Application No.: 10/500776  
Docket No.: CL1927USPCT

### **REMARKS**

FIG. 1

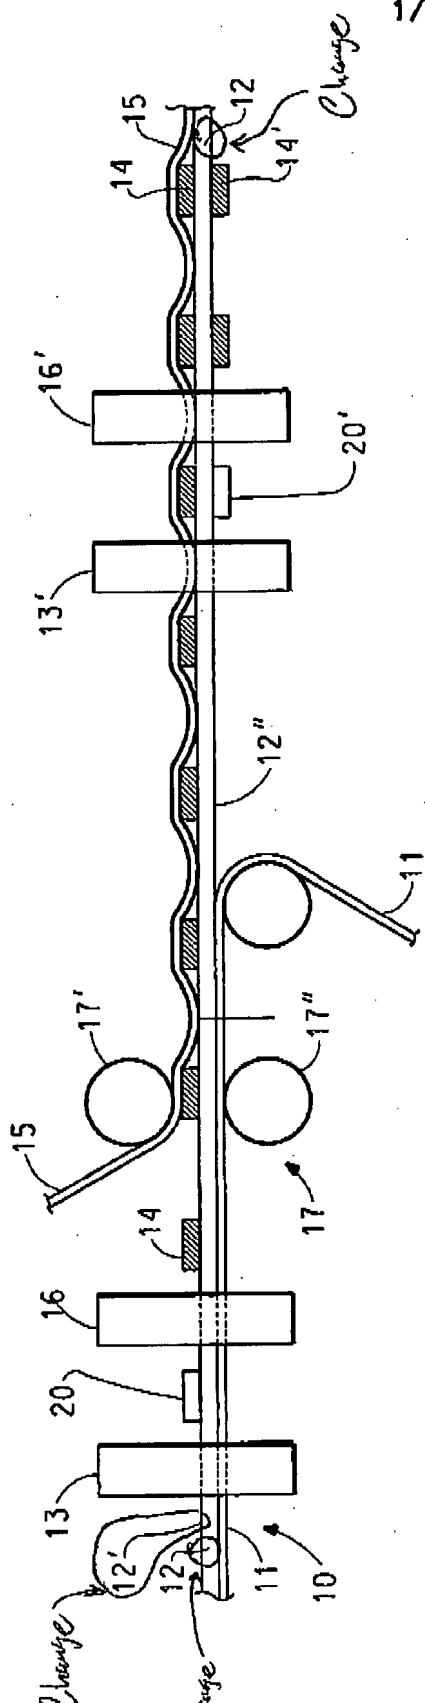
The Examiner objected to the drawing because the reference character "12" was used to designate both the polymer membrane and the first surface. The Examiner noted that in the specification, the first surface is designated 12'. Applicants note that the reference characters 12, 12' and 12'' are clearly shown in Figure 2 of the drawings. Applicants have amended Figure 1 of the drawings by extending the line extending from the reference character 12 (both instances) to more clearly show that reference character 12 is identifying the membrane, and Applicants have added the reference character 12' as already appeared in Figure 2. These changes are fully supported in the specification at page 14, lines 19-24 and in Figure 2 of the drawings.

Please amend Figure 1 as shown on the replacement sheet attached to this Amendment. An annotated copy of the replacement sheet showing the changes to Figure 1 is also attached to this Amendment.
